Gables Station

COMPREHENSIVE PLAN MAP AMENDMENT
ZONING MAP AMENDMENT
ZONING CODE TEXT AMENDMENT
PLANNED AREA DEVELOPMENT
MIXED USE SITE PLAN

215 AND 251 S. DIXIE HIGHWAY
CITY COMMISSION 2ND READING
JULY 26, 2016

#2: FPL POWERLINES

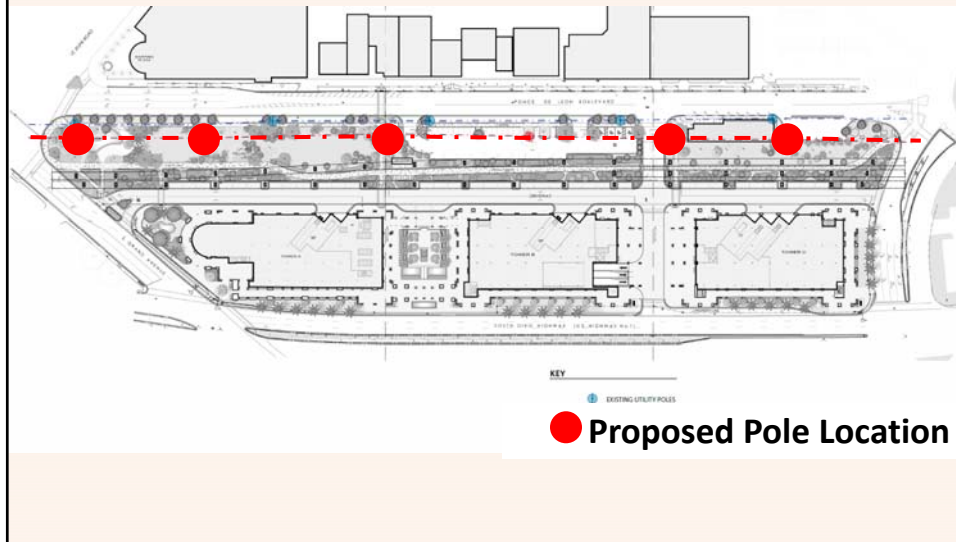
1. Reduce building height while maintaining the same percentage of open space.
2. Show FPL powerline locations in drawings of the Underline.
3. Finalize the trolley contribution proposal.
4. Confirm the timing of the Underline improvements.
5. Update the Traffic Impact Study.
6. Provide the Art in Public Places concept.
7. Update site plan to include more landscaping at the ground level.

#5: TRAFFIC IMPACT STUDY

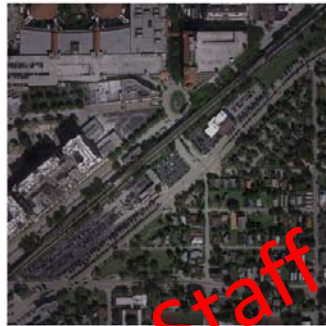
1. Pages 2, 9, 16, 22, 25, 28 and 29: On pages 2, 9, 16, 22, 25, 28 and 29, clarify for the reader what the acronym VMP represents (Vehicle Miles Per Hour).

2. Page 4: Under "where T, U, and R represent", clarify the existing statement to indicate that traffic volume is based on both with and without the project.

4. Page 16: Text should refer to the historical count station traffic data available in Appendix C.
 Response: Text has been added in reference Appendix C.

5. Pages 13-20: Trip Generation:
 - a. The text states that a 10% adjustment was applied to the trip generation to account for other modes of transportation. Actually, the trip generation table shows a 10% adjustment for transit trips and 10% adjustment for pedestrian trips (from the apartments only). Text should match table calculations.

Response: In order to clarify the VMP acronym, a legend has been added to all exhibits as needed. The VMP acronym is defined in Exhibit A, Merck Plan, a legend has been added to all exhibits as needed.

Response: The statement has been revised to read: "Traffic volume is based on both with and without the project."
 The following items have been revised:
 Page 2, 9, 16, 22, 25, 28 and 29: On pages 2, 9, 16, 22, 25, 28 and 29, clarify for the reader what the acronym VMP represents (Vehicle Miles Per Hour).

Response: Text has been revised to match the adjustments shown on Exhibit B.
 - b. The methodology statement assumed 554 apt. units, 268 hotel rooms, and 88,000 of retail. The current proposal is for 480 apt. units, 147 rooms, and 65,000 of retail. The text reference to the methodology should note the reduction.

Response: Since the submital of the traffic study, the proposed development plan has been revised. The study has been updated for the current development plan.
